REQUEST FOR TENDER No. 20-062

Meadowood Community Centre Construction

**Addendum 4 (17 pages)
Issued: December 3, 2020**

ADDENDUM – 04

FIELD	TANK
FROM PARCEL BOUNDARY, BUILDING, DOMESTIC WATERLINE, INTERCEPTOR DRAIN (UPSTREAM)	3m (10ft)	1m (3ft)
BREAK-OUT POINT - PERIMETER DRAIN MARINE WATER	15m (50ft)	10m (33ft)
FROM SOURCE OF DOMESTIC/FRESH WATER	30m (100ft)	15m (50ft)

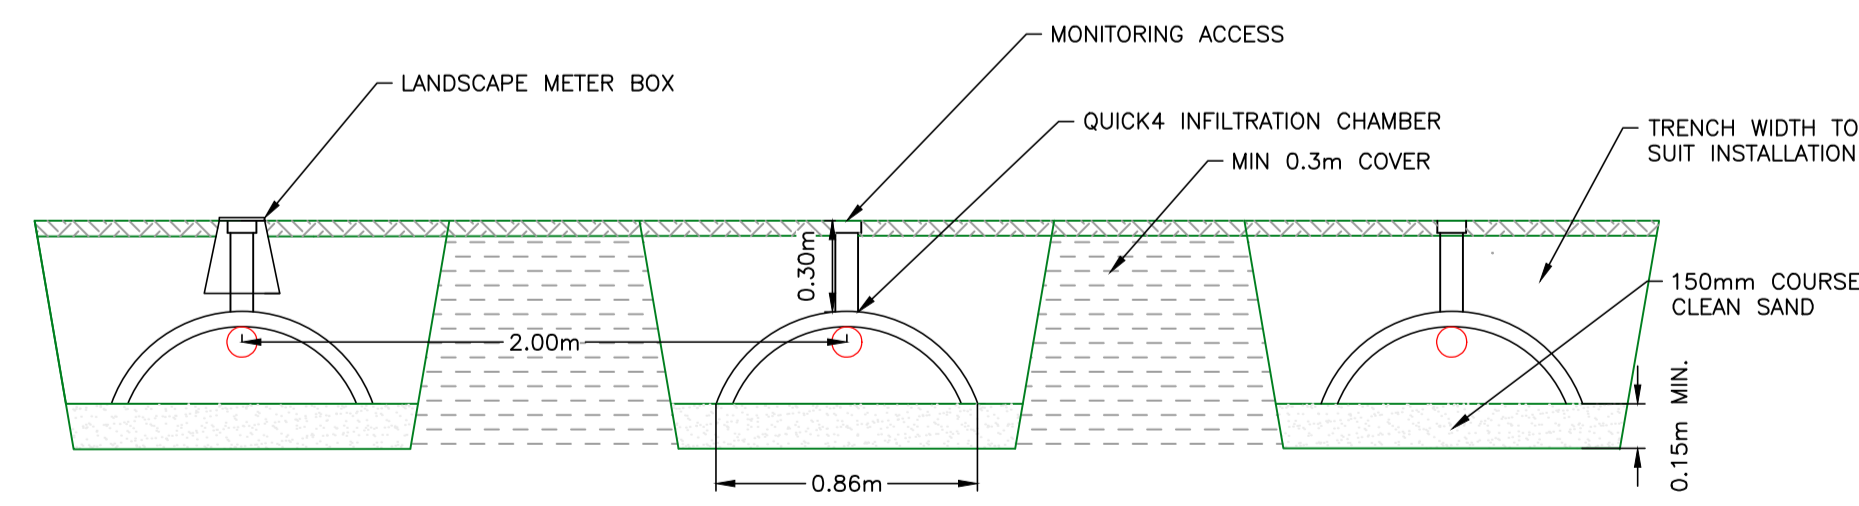
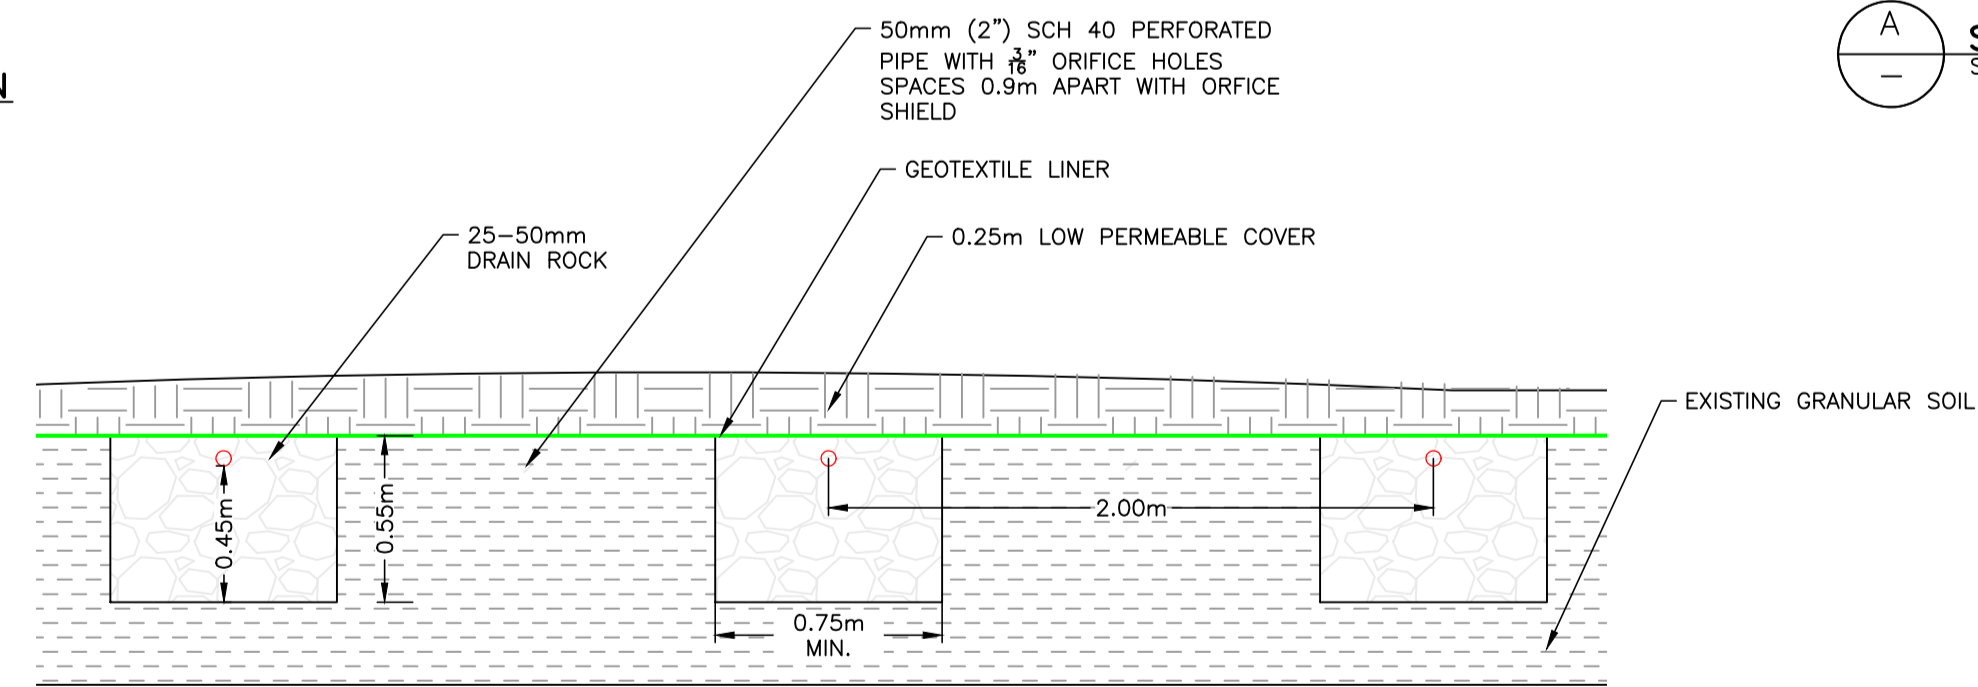
NO.	DATE	BY	REVISIONS	ENG
	2020.11.30	C.S.	CHANGED FITTINGS AND ADDED FLOAT TREE	M.S.
(1)	2020.12.01	C.S.	ADDED PIPE THICKNESSES	M.S.

HORIZ. SCALE:	AS SHOWN	DRAWING NO.:	C02
SHEET 1 OF 1	VERSION	20-539	1

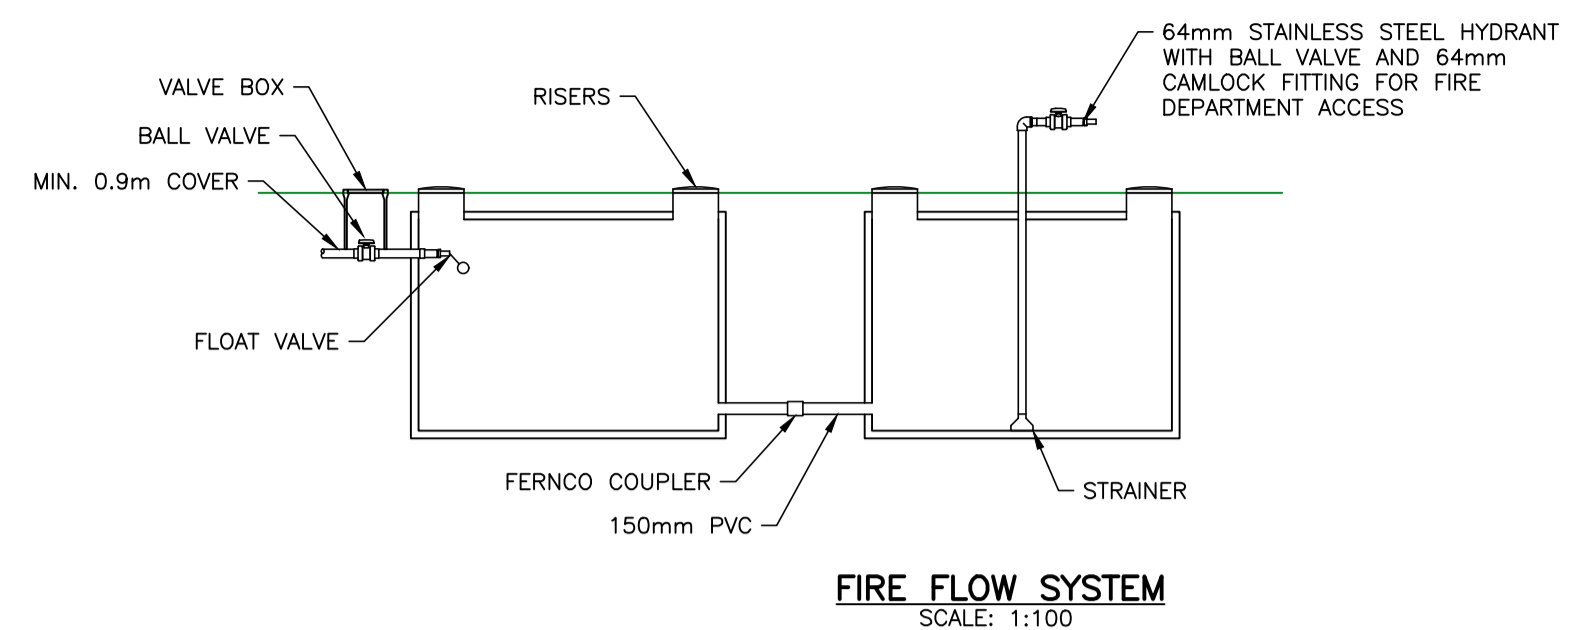
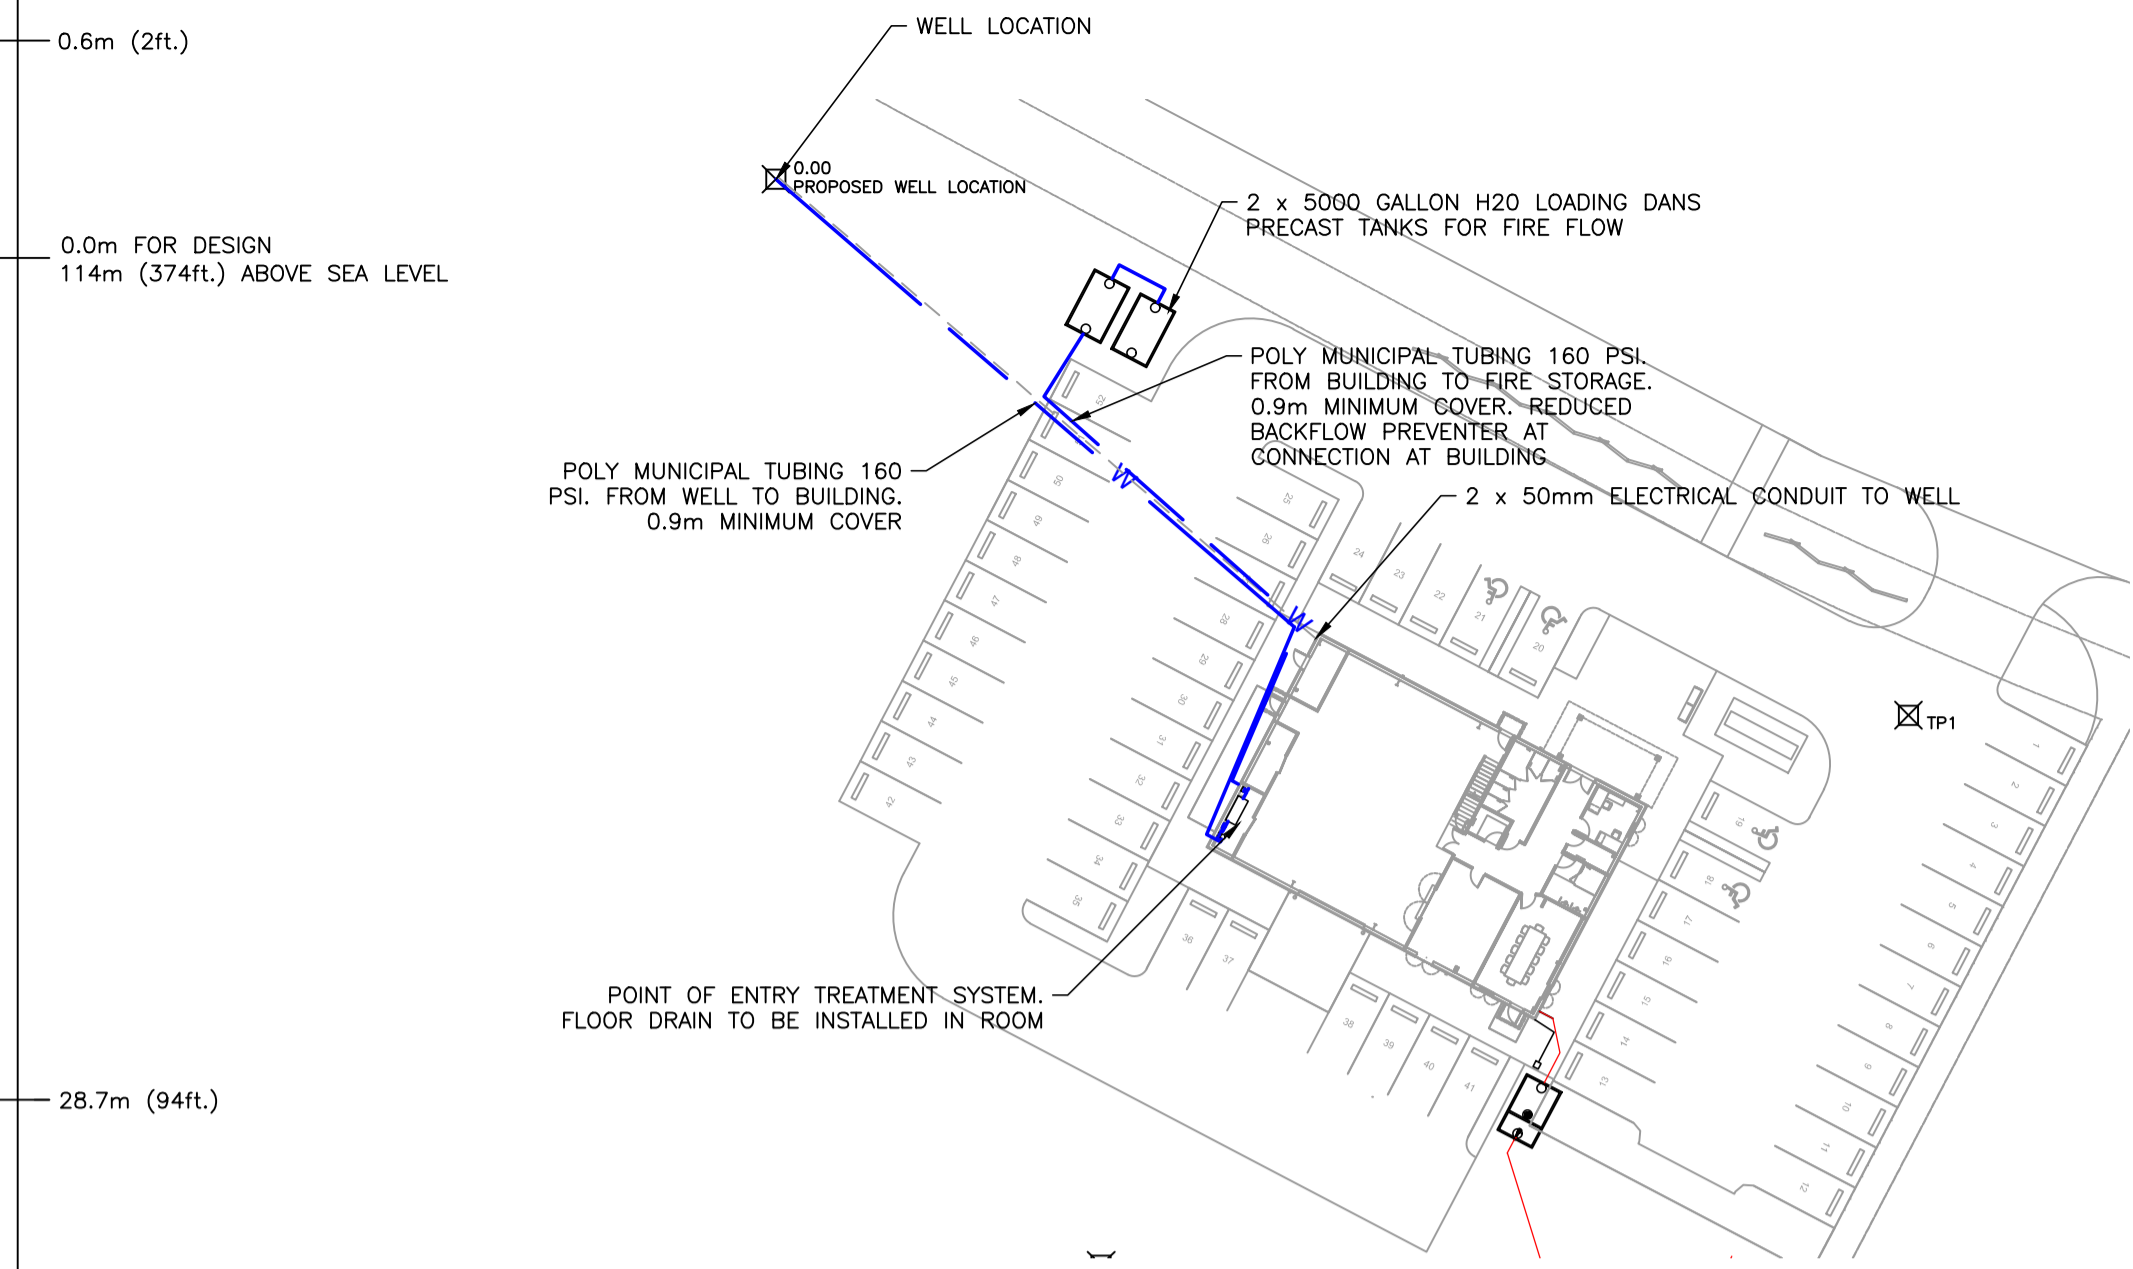
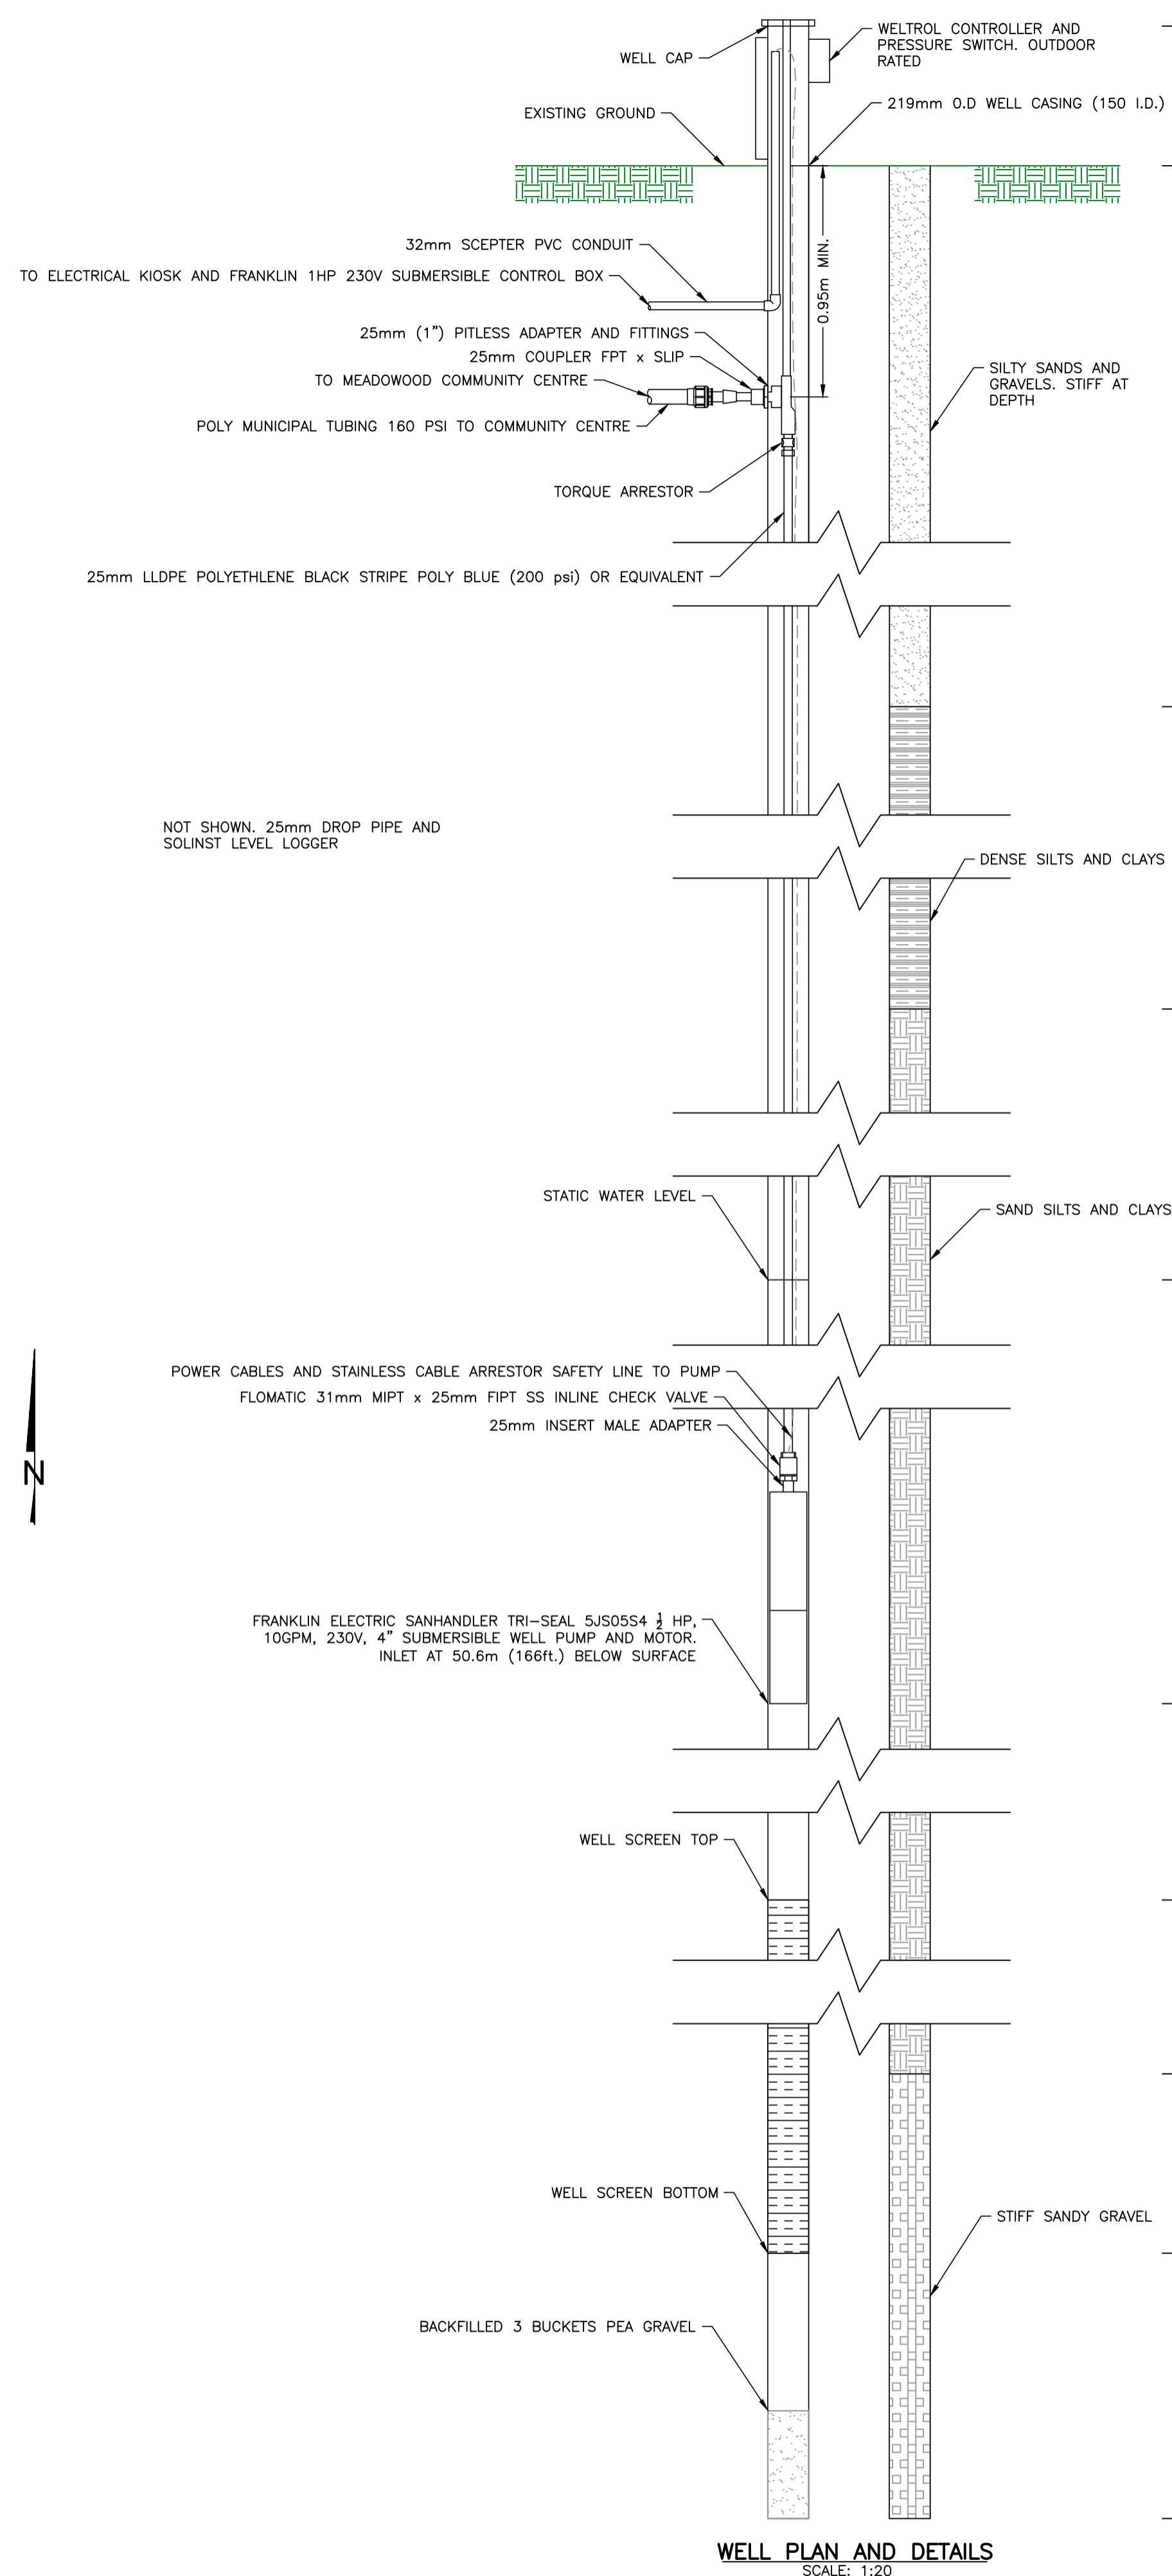
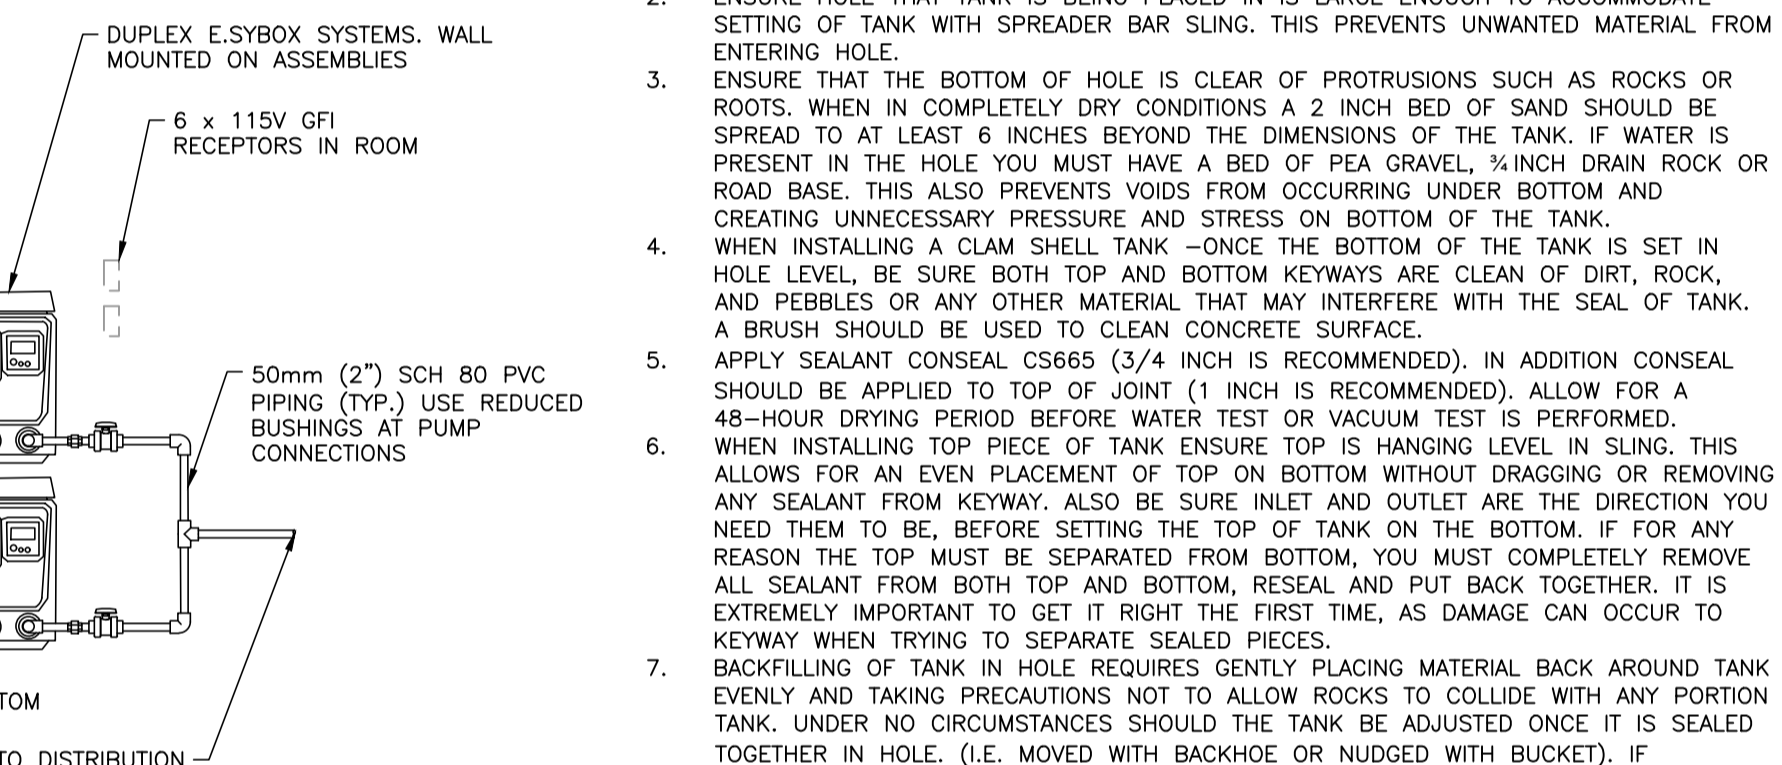
- .1 Updated MSR drawing C02 dated 2020.11.23 is attached.
- .2 The electrical duct can be installed in the common trench to the well head location

NO.	DATE	BY	REVISIONS	ENG
1	2020.12.01	C.S.	POINT OF ENTRY SYSTEM AND FIRE RETURN	X.X.
